Town of Rolesville, NC
Department of Planning

Comments on #PSP-26-0002 - Planning & Zoning: Preliminary Subdivision Plat

Application Number: #PSP-26-0002
Application Type: Preliminary Subdivision Plat
Date: October 1, 2026
Address: 2206 Wait Ave Wake Forest NC 27587

ATTICUS WOODS

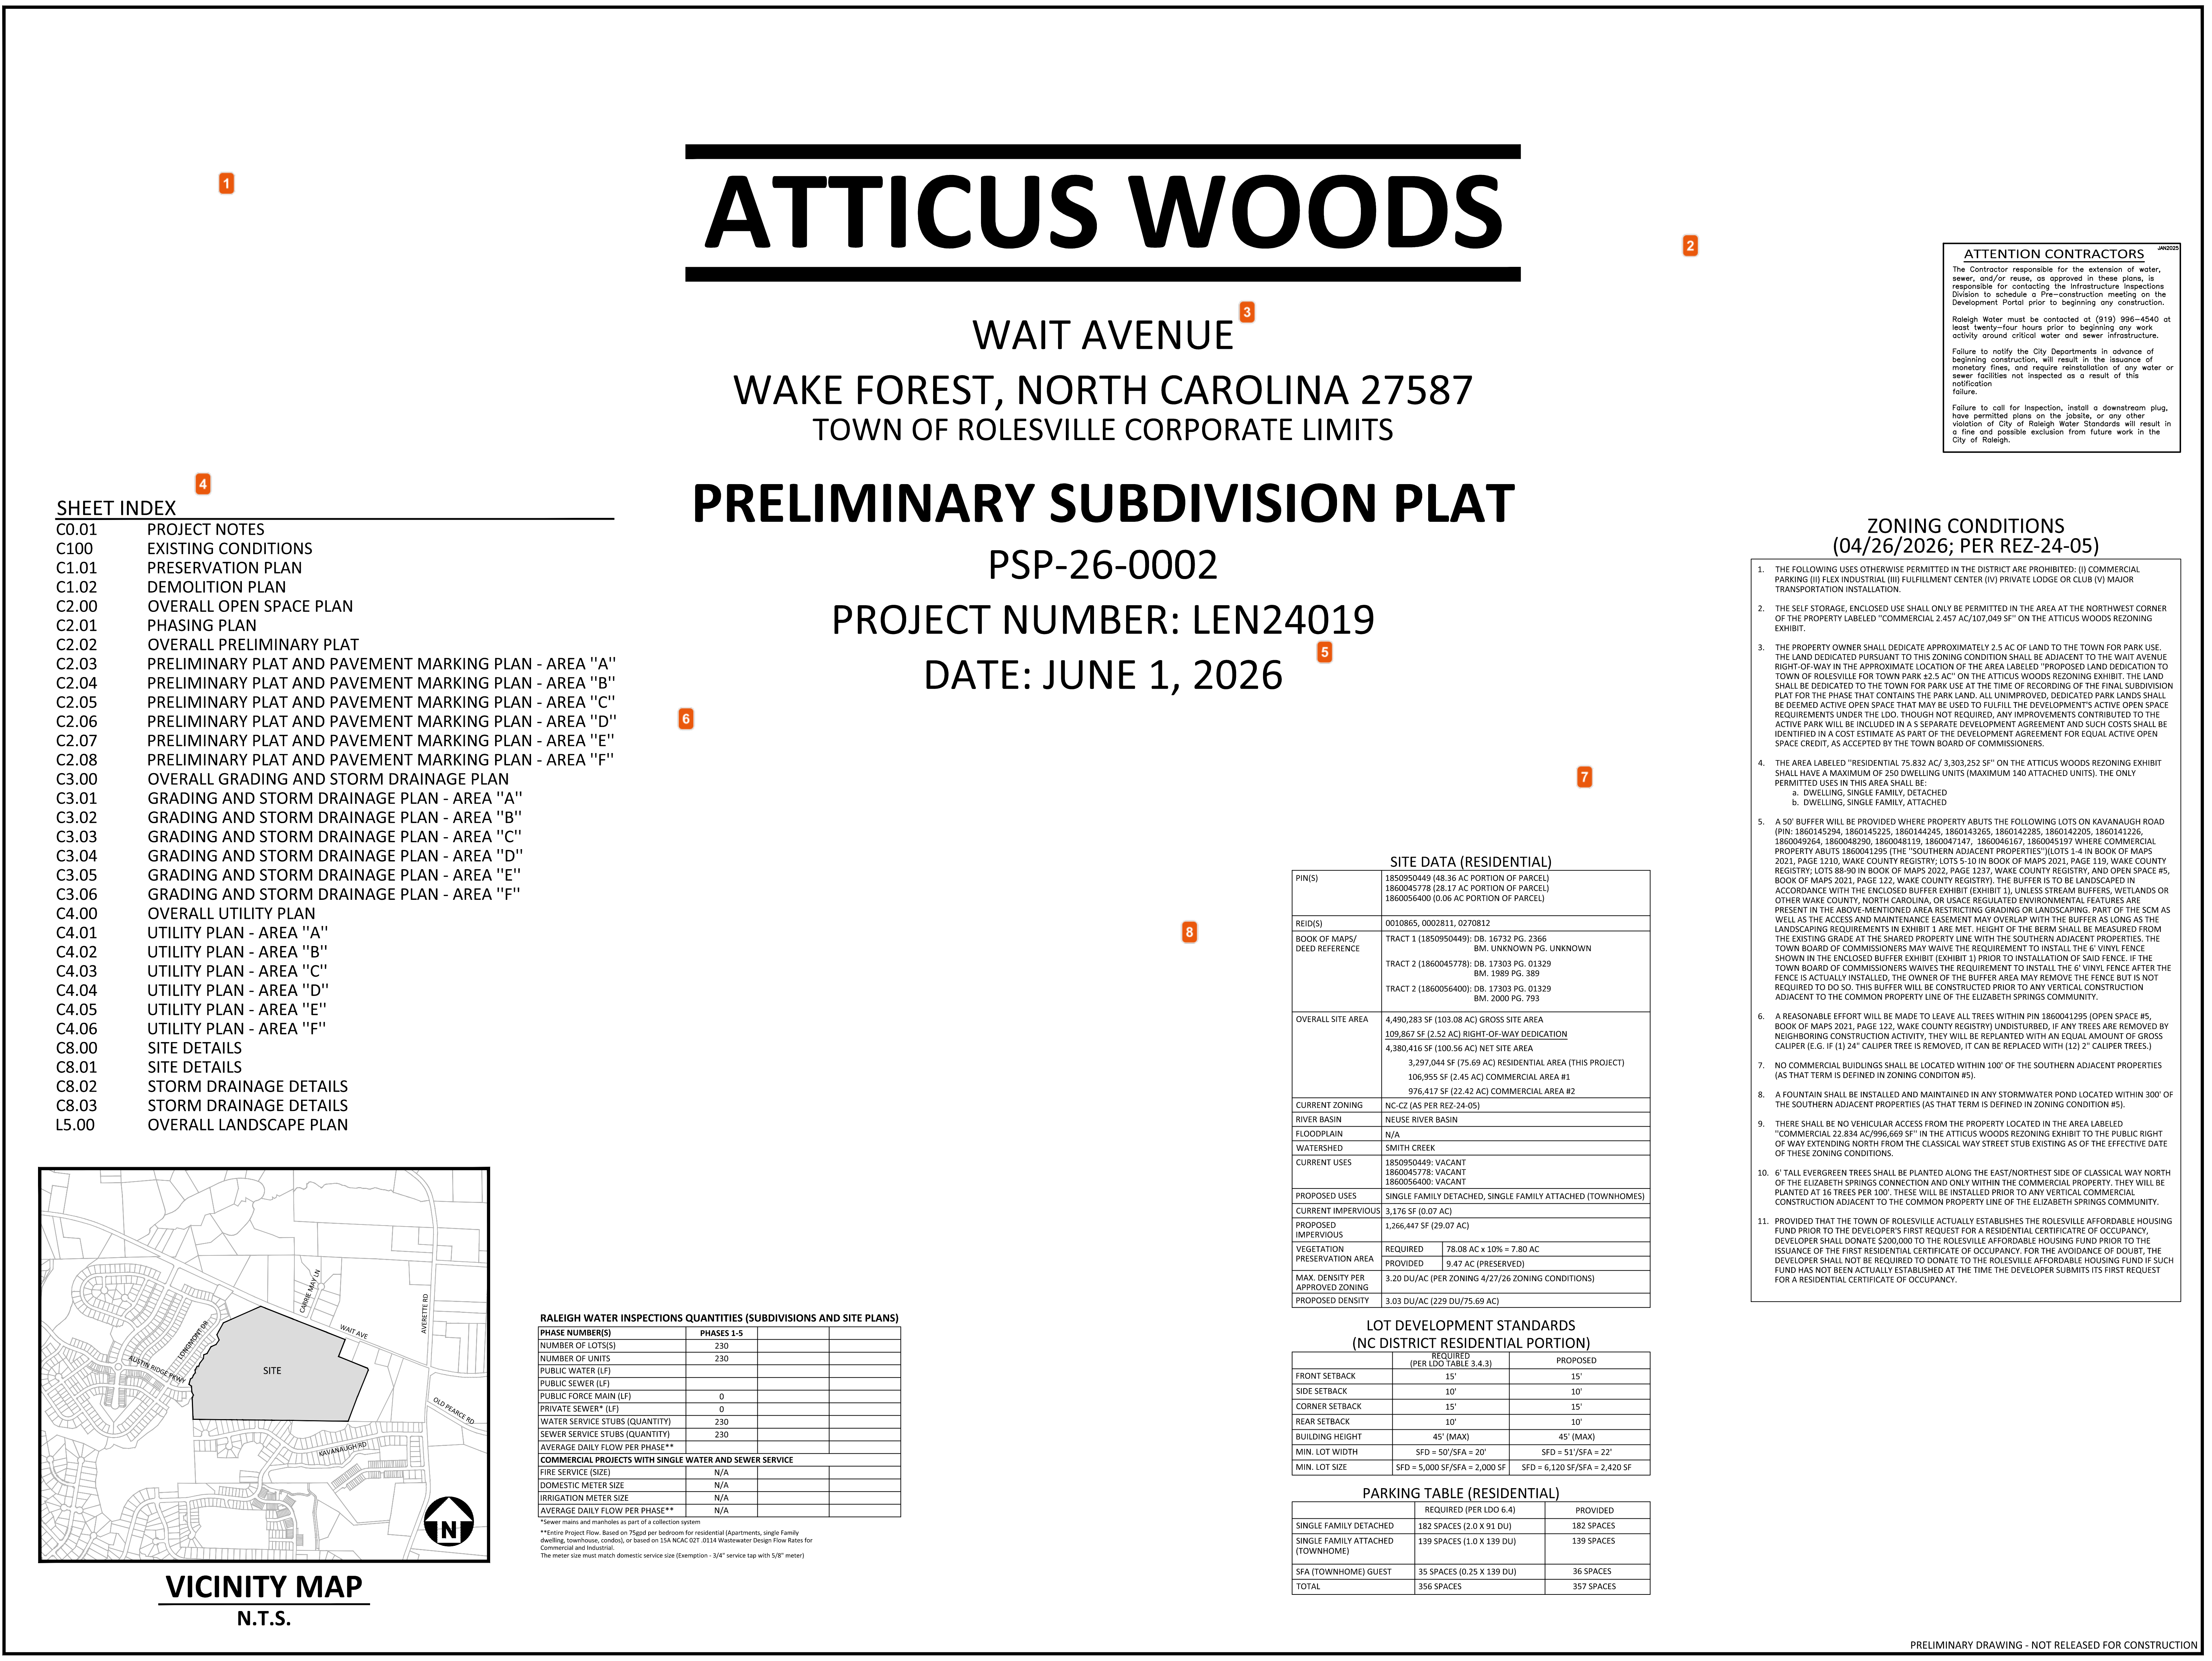
At this point, per the Site Data Table, this is a subdivision of 3 properties - PIN x0449 is addressed as 2028 Wait Ave / PIN x5578 is addressed as 2206 Wait Ave / PINx6400 is addressed as 2200 Wait Avenue - why is there No Address here in the title?

Add "Cover Sheet" to the index - it is the 1st sheet. It would be great if you could also add a "#" column, 1 through ## - it makes it that much easier to use a plan set esp. PDF when you can see in the Index the sheet you want is number 17, and then you go to the little sheet by sheet scroll and enter "17" of 33 and ENTER and it takes you there. Randomly scrolling and scouring the lower right hand corner for C#.## is cumbersome. thank you.

Pls add the September revision date.

C2.03 through C2.08 the Pavement marking information is CID level - a Prelim PLat clarifies rights-of-way widths - not the final paint striping on the final lift of asphalt. Remove the construction specific information, but if these sheets are needed as the tiled blow-ups of the overall, then they can stay. Keep in mind - fine-level construction level detail is for CID

The Legal Description field contains a summary of the proposed land uses rather than the actual legal description of the property. Please update this field to provide the Book of Maps or Register of Deeds Book and Page numbers for the parcels (e.g., DB 16732 PG 2366 and DB 17303 PG 01329), as indicated on your Site Data table.
